Southern Garments Ltd

Zirabo, Ashulia, Savar, Dhaka
(23.912349 N, 90.314662 E)
21 March 2015

Observations

Observations – Building 1

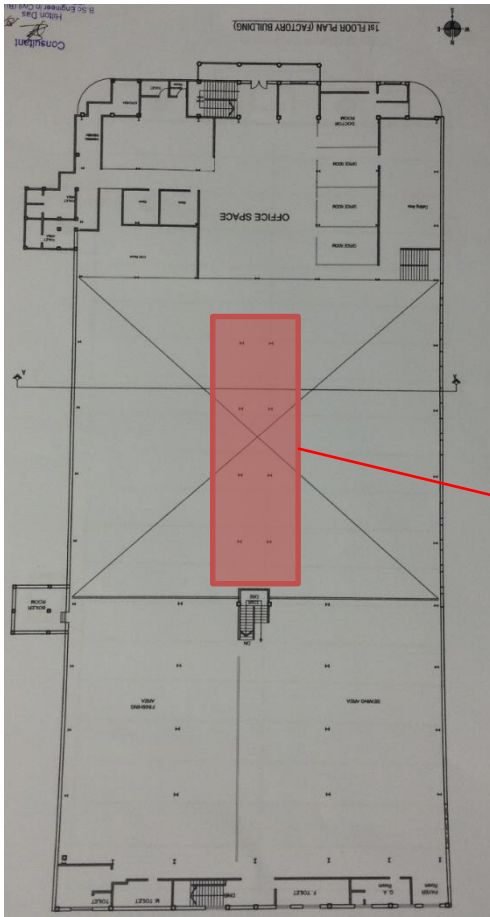
**Steel columns in Building 1
appear to be too slender**

Steel columns in mid-span appear to be very slender.

Observations – Male Toilets

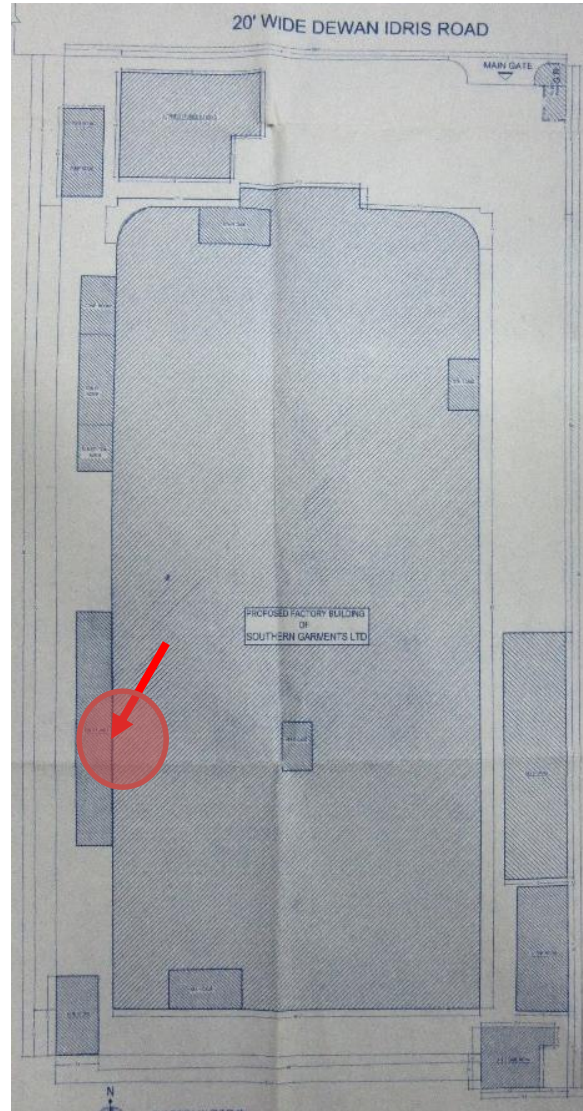
Cracks in walls of male toilet below water tank

Vertical cracks in walls of male toilets underneath water tank

Observations – Building 1

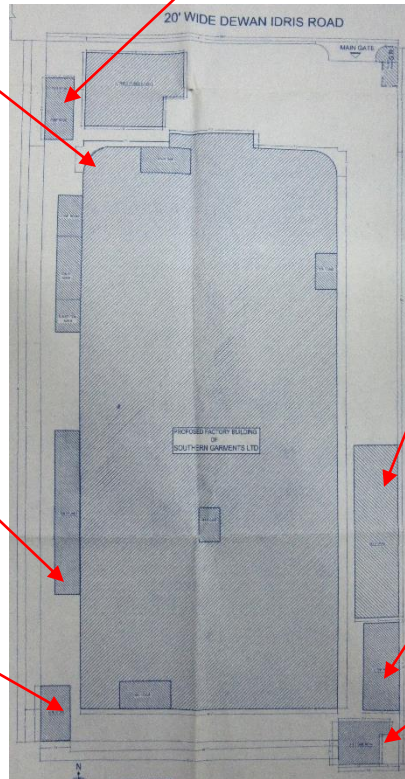
Bracing of Steel Shed/Portal Frame in Building 1 needs to be tied

Bracing appear to be not tied in both directions.

Observations – Building 1

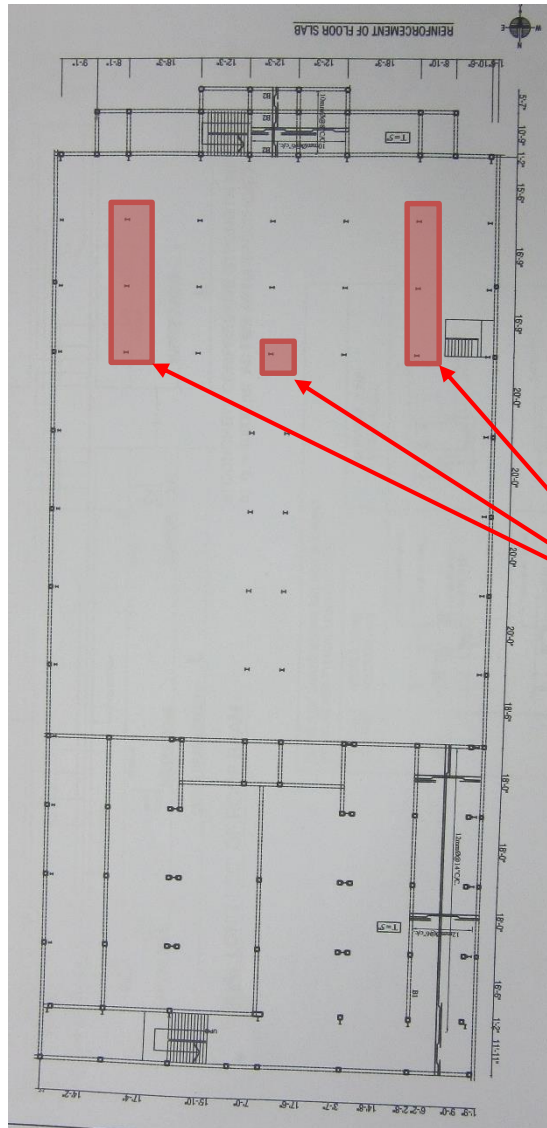
Discrepancies between the structural drawings and the As-Built structure

List of discrepancies:

- Missing columns in several locations on mezzanine floor in Building 1

Beam layout for mezzanine floor with columns below on ground floor.

Observations – Building 1

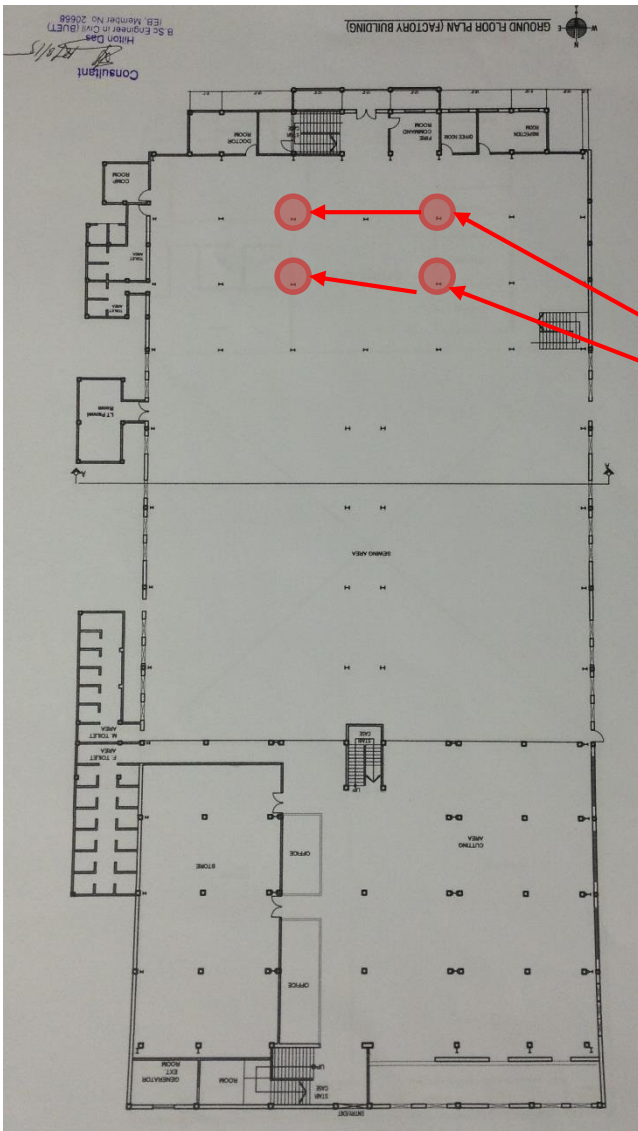
Double column bolted together

Signs of strengthening:

- Double column bolted together (one of the two has no contact to foundation). This details is found on 4 locations on the ground floor.

Two columns bolted together in 4 locations on ground floor.

Observations – Building 1

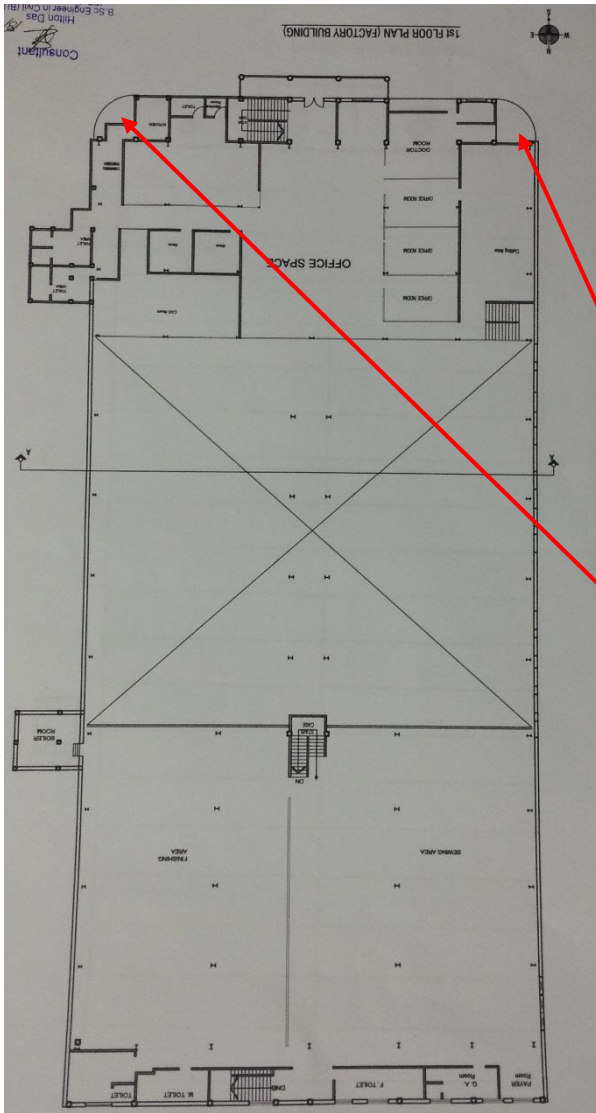
Falling hazard at balconies of Building 1

Falling hazards at two balconies in Building 1 on first floor.
